# COMMUNITY BOARD FEEDBACK PACKAGE

## COMMUNITY BOARD RECOMMENDATION FORM

**Business Name:** MOM'S MIDTOWN

**Cafe Location:** 701 9TH AVE, NEW YORK, NY, 10019

REVISED SITE PLAN

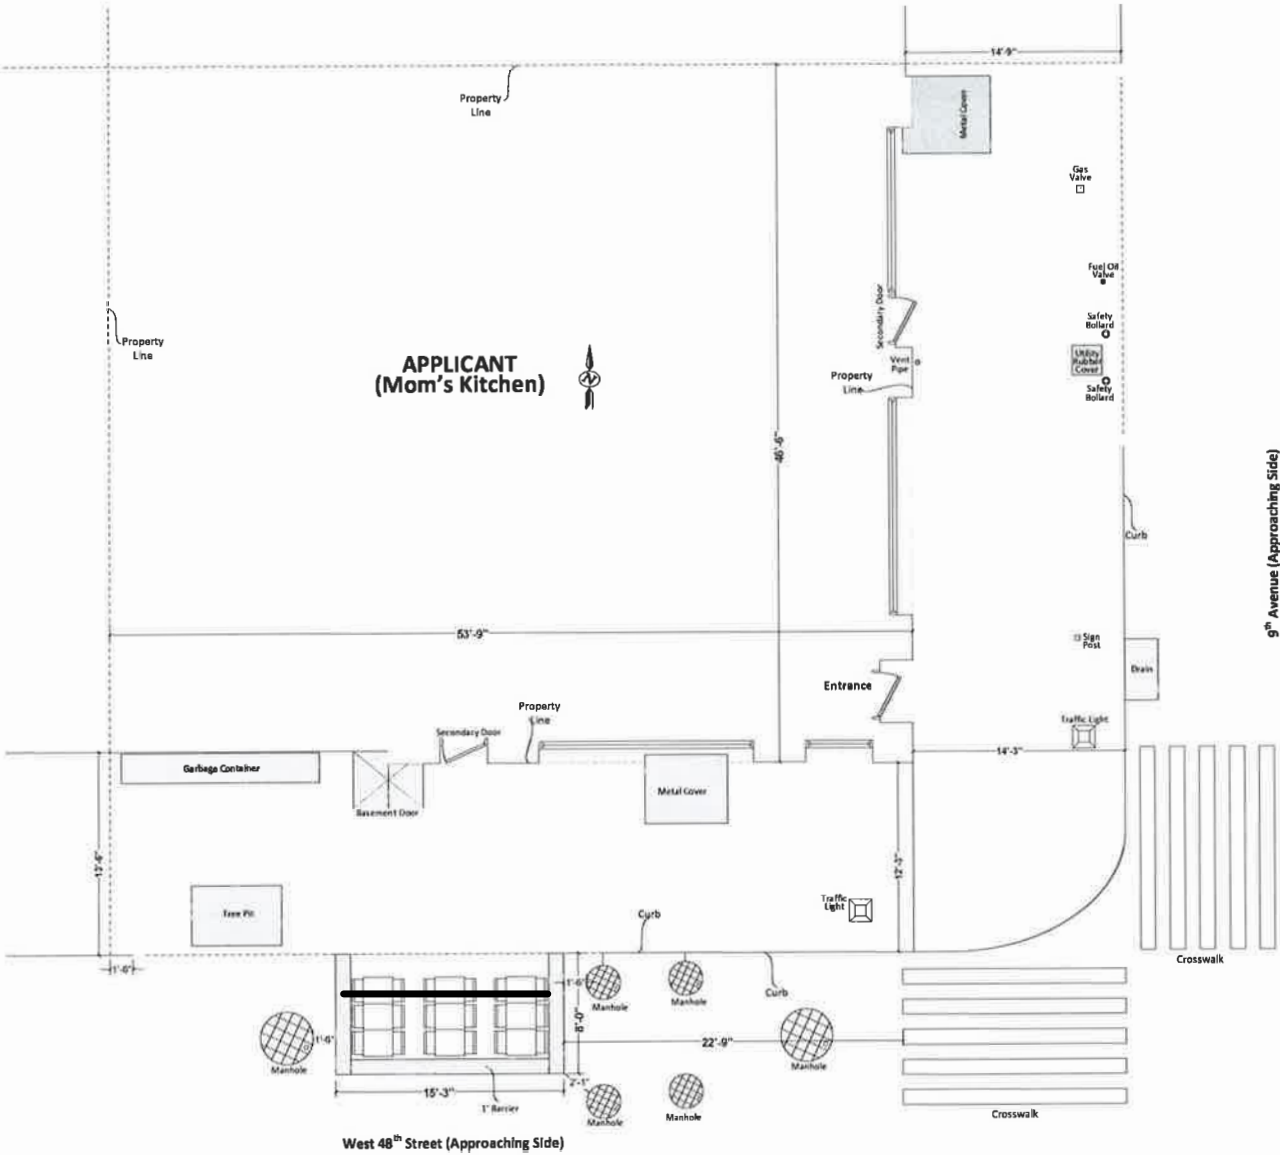
The number of tables and chairs on the proposed Site Plan (9 tables with 2 chairs each) cannot fit in the proposed footprint of the roadway cafe. Applicant has agreed to remove 3 tables with 2 chairs each from the north end of the cafe, reducing the cafe to 6 tables with 2 chairs each.

To fit within the proposed footprint of the roadway cafe, MCB4 requests modifications to the cafe. Applicant has agreed to these modifications and has removed 3 tables with 2 chairs each. A Revised Site Plan, reducing the cafe to 6 tables with 2 chairs each -- to which applicant has agreed -- is attached.

To fit within the proposed footprint of the roadway cafe, MCB4 requests modifications to the cafe. Applicant has agreed to these modifications and has removed 3 tables with 2 chairs each. A Revised Site Plan, reducing the cafe to 6 tables with 2 chairs each -- to which applicant has agreed -- is attached.
